## DOOR LOCK CONTROL SYSTEM

### ■ DESCRIPTION

188BE09

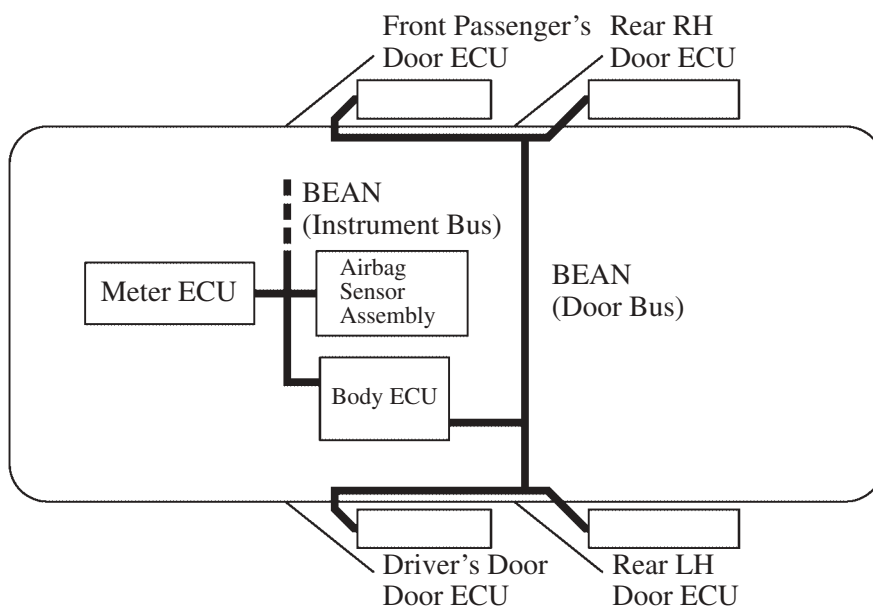
“Collision door lock release” functions have been added to the door lock control system of the new GS430/300 models for Europe. Furthermore, for improved theft deterrence, a double locking system is standard equipment on the RHD model for Europe and optional equipment on the LHD model for Europe.
